# UNITED STATES PATENT AND TRADEMARK OFFICE

APPLICATION NO.	FILING DATE	FIRST NAMED INVENTOR	ATTORNEY DOCKET NO.	CONFIRMATION NO.
10/615,991	07/10/2003	Cheol-Jin Park	Q75619	1227
23373 75	90 02/16/2005	EXAMIN		INER
SUGHRUE MION, PLLC			nguyen, tuyen t	
2100 PENNSYI SUITE 800	LVANIA AVENUE, N.W	<i>7</i> .	ART UNIT	PAPER NUMBER
WASHINGTON	N, DC 20037		2832

#### **DETAILED ACTION**

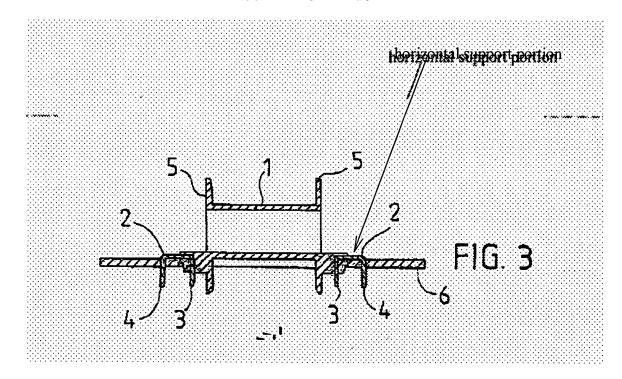
Applicant argues that there is simply no indication in Kataja that its connectors 2 having any support portions comparable to that recited in claim 1.

Examiner invite application to look at figure 3 below, horizontal support portion of pin [2], resting on the printed circuit board [6] providing the support function.
